Pacific Gas & Electric Company
ELC (Corp ID 39)
Status of Advice Letter 7010E
As of January 17, 2024

Subject: Modifications to Electric Tariff Rule 21 to Update IEEE 1547.1-2020 Test Procedures for Phase 2 and 3 Requirements in Compliance with Resolutions E-5000 and E-5036

Advice 7010-E

Pacific Gas and Electric Company (PG&E) hereby submits this Tier 1 advice letter to incorporate modifications to PG&E's Electric Rule 21 (Rule 21), replacing the language in Rule 21 Section Hh in its entirety with the recently approved language in Section P and retiring Section P. The modifications contained herein are consistent with the process approved within PG&E's Advice 6635-E/E-A/E-B/E-C, in furtherance of transitioning from UL1741SA to UL1741SB requirements and aligning with IEEE¹ 1547-2018 and IEEE 1547.1-2020 standards for inverter-based Generating Facilities, pursuant to California Public Utilities Commission (CPUC, or Commission) Resolutions E-5000 and E-5036.

Figure Hh-1: Voltage and Reactive Default Settings

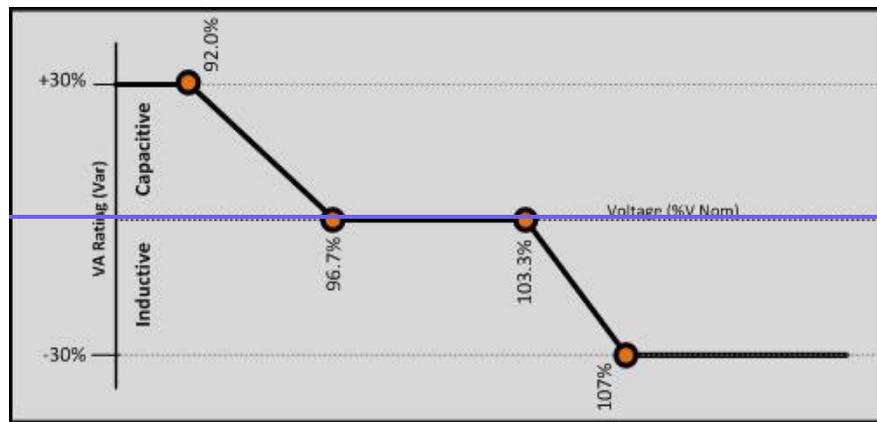
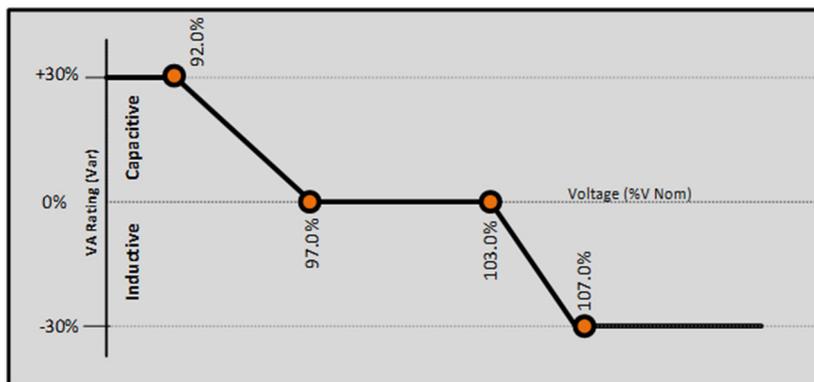
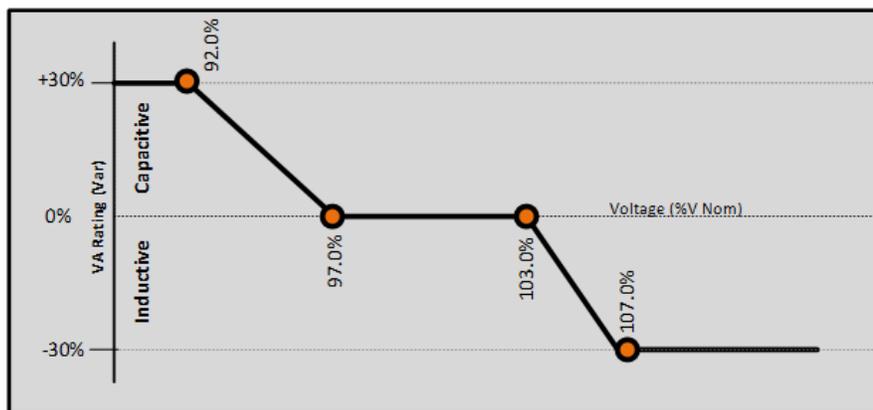
Table Hh-3 and Figure Hh-1 depict the default setting, which should be applied for all inverter size. Specific volt/var settings may be required for larger generating facilities (such as 100 kW or greater) or for specific areas with the Distribution System as determined by the Distribution Provider.

~~Table Hh-4 and Figure Hh-1 depict the default settings, which should be applied for all inverter sizes. Specific volt/var settings may be required for larger Generating Facilities (such as 100 kw or greater), or for specific areas with the Distribution Systems as determined by the Distribution Provider.~~

~~Figure P-1: Voltage and Reactive Default Settings~~

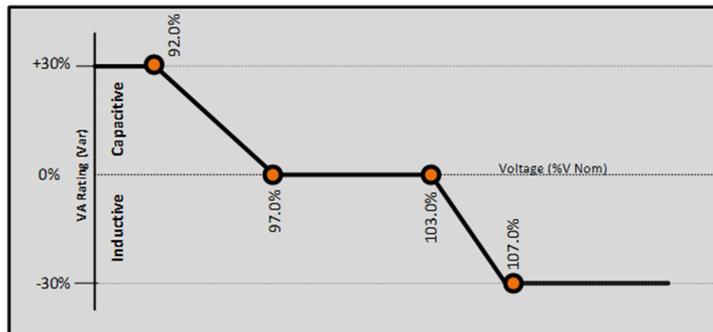
~~Table P-3 and Figure P-1 depict the default setting, which should be applied for all inverter size. Specific volt/var settings may be required for larger generating facilities (such as 100 kW or greater) or for specific areas with the Distribution System as determined by the Distribution Provider.~~
